**FINDINGS AND RECOMMENDATION
OFFICE OF PLANNING AND ZONING
ANNE ARUNDEL COUNTY, MARYLAND**

CASE NUMBER: 2024-0211-V

The applicant is requesting a variance to allow an accessory structure (detached garage) with greater height than allowed¹ on property located at 580 Brightwood Road in Millersville.

SITE DEVELOPMENT PLAN
LUTZ PROPERTY
 580 BRIGHTWOOD ROAD
 MILLERSVILLE, MD 21108
 TAX MAP 22, BLOCK 12, PARCEL 209, TAX ACCOUNT # 2000-901-8550, ZONING R2
 DATE: NOVEMBER 13, 2024
 ASSESSMENT DISTRICT: ANNE ARUNDINE COUNTY, MARYLAND
 SHEET 1 of 1

PROPOSED DEVELOPMENT CONCEPT PLAN
 SCALE 1"=40'

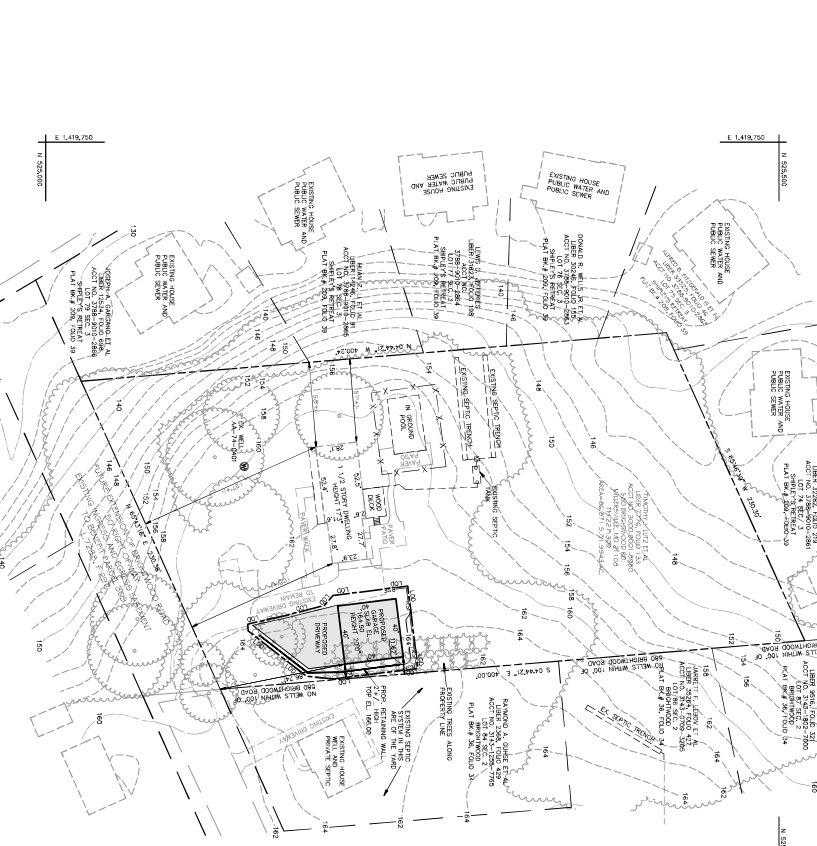
§ 18-4-601 of the Anne Arundel County Zoning Ordinance limits the height of an accessory structure in an R2 District to 25 feet or the height of the principal structure, whichever is less. The existing dwelling is 17'-3" (17.25') high; the proposed garage would measure 20' high, necessitating a variance of 2.75' to the maximum accessory structure height allowed.

The **Health Department** commented that additional information is needed regarding the type and location of the water supply well and on-site sewage disposal system for the neighboring property at 578 Brightwood Road. No other comments were provided.

The type and location of the water supply well and on-site sewage disposal system for neighboring property 578 Brightwood Road.

Based upon the standards set forth in § 18-16-305 of the Code under which a variance may be granted, this Office recommends *approval* of the requested zoning variance to § 18-4-601 to allow an accessory structure (detached garage) with a height of 20 feet to be constructed 2.75 feet higher than the principal structure, in accordance with the site plan submitted by the applicants.
